EA Engineering, Science,
and Technology, Inc.

23 August, 2000

RE: Expansion of LOOW Phase II RI (Response to Phase II RI Letter 03)

SUBJECT: Phase II RI Letter 03

FIGURE 1 MAP OF FORMER LOOW COMPONENT 2 SITE

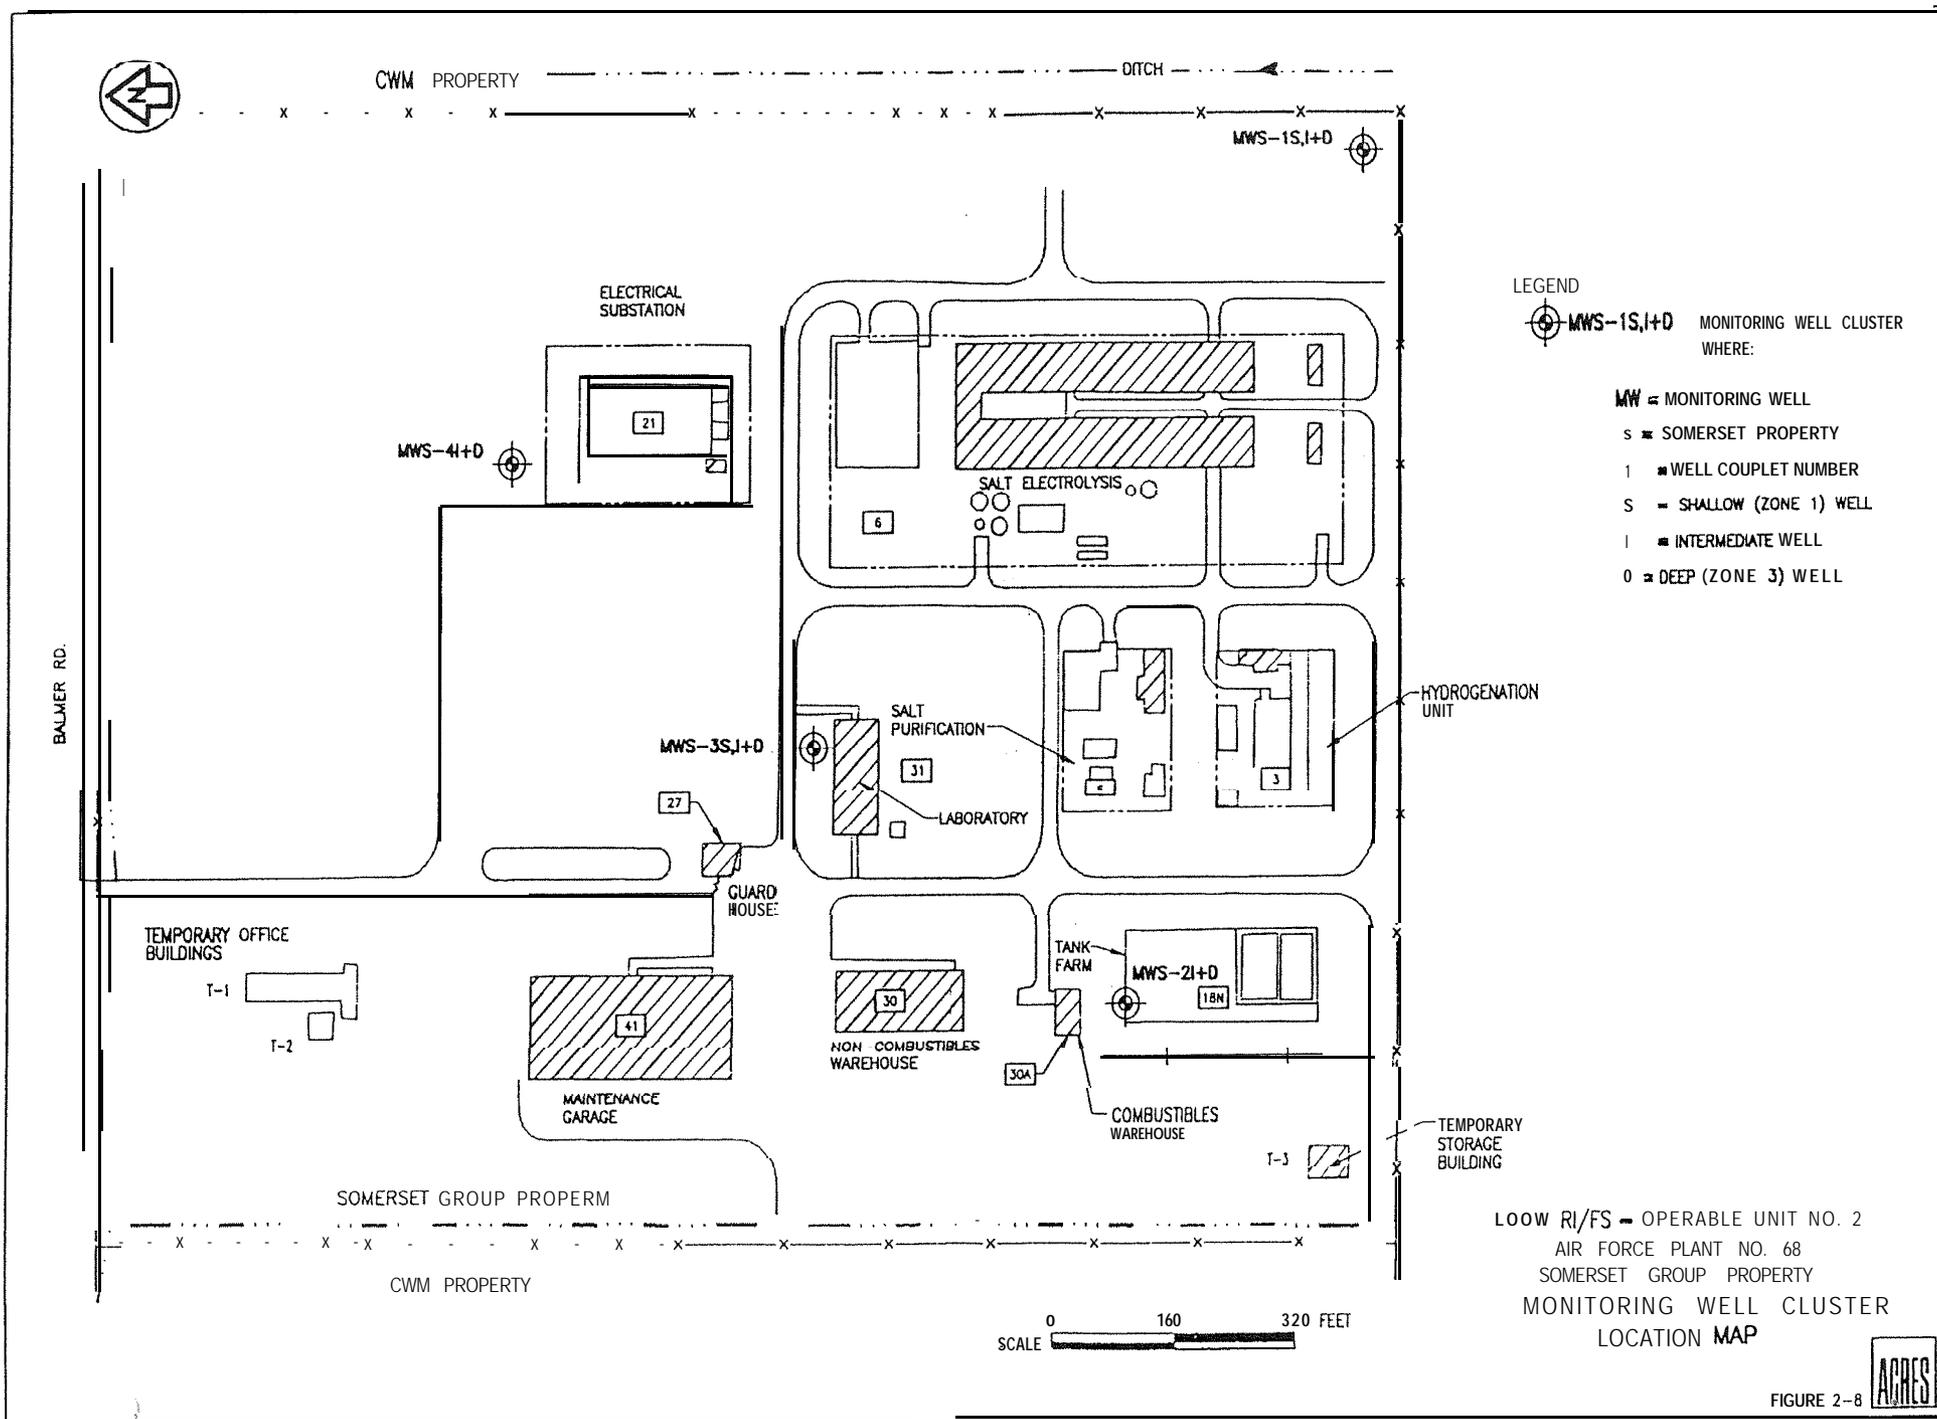
According to the Preliminary Contaminant Assessment Report (Acres 1992), there are ten existing wells at Component 2, Somerset Property(see Figure 1).

MWS-41 and D
MWS-3S, I and D
MWS-21 and D
MWS-1S, I and D

Where S, I, and D represent shallow, intermediate, and deep screening intervals, respectively. A reconnaissance of existing wells at Component 2 will be performed to determine the condition of the well. The wells will be checked for breaks and blockages in the well casing, evidence of frost heaving, lock integrity and PVC riser integrity. In addition, the depth to the bottom of the well, and to the water table will be measured and recorded. Attached are two tables, from ACRES Preliminary Contamination Assessment Report (1992), which provide information from well installation and water level measurements, respectively (see Table B-15-1 and Table B-15-2).
